Product Change Notification

PCN-A-1060607

PCN TOPIC: Winmate improves the stylus design for M101 series tablet PC.

Comparison Table:

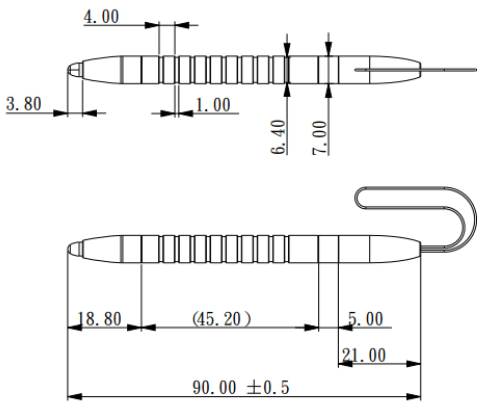
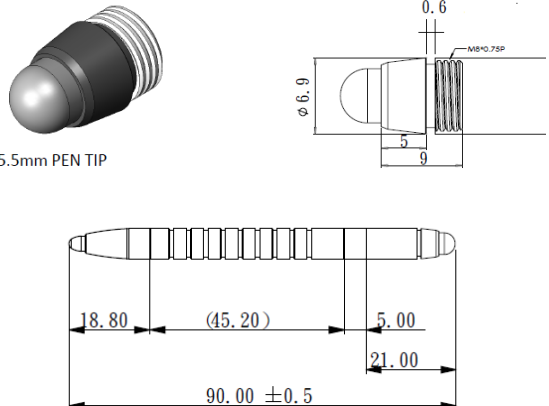
DETAILS: Winmate changes the stylus design for M101 series Tablet PC. The original pen tip is hard-tip design has been changed to two-side pen tip in new design, where one side is soft rubber tip, and the other side is hard-tip. Refer to a comparison table below for more details.

Current Design	NEW Design								
<p>Hard-tip stylus</p> <p><i>Photo</i></p>  <table border="1" style="margin-left: auto; margin-right: auto;"> <tr> <td>Stylus Dimension</td> <td>90.0 x 7.0 mm</td> </tr> <tr> <td>Stylus Tip Diameter</td> <td>(Hard-tip) 3.5 mm</td> </tr> </table> <p><i>Drawing</i></p> 	Stylus Dimension	90.0 x 7.0 mm	Stylus Tip Diameter	(Hard-tip) 3.5 mm	<p>One side is soft rubber tip, the other side is hard-tip</p> <p><i>Photo</i></p>  <table border="1" style="margin-left: auto; margin-right: auto;"> <tr> <td>Stylus Dimension</td> <td>90.0 x 7.0 mm</td> </tr> <tr> <td>Stylus Tip Diameter</td> <td>(Soft rubber tip) 5.5 mm (Hard-tip) 3.5 mm</td> </tr> </table> <p><i>Drawing</i></p> 	Stylus Dimension	90.0 x 7.0 mm	Stylus Tip Diameter	(Soft rubber tip) 5.5 mm (Hard-tip) 3.5 mm
Stylus Dimension	90.0 x 7.0 mm								
Stylus Tip Diameter	(Hard-tip) 3.5 mm								
Stylus Dimension	90.0 x 7.0 mm

Stylus Tip Diameter	(Soft rubber tip) 5.5 mm (Hard-tip) 3.5 mm
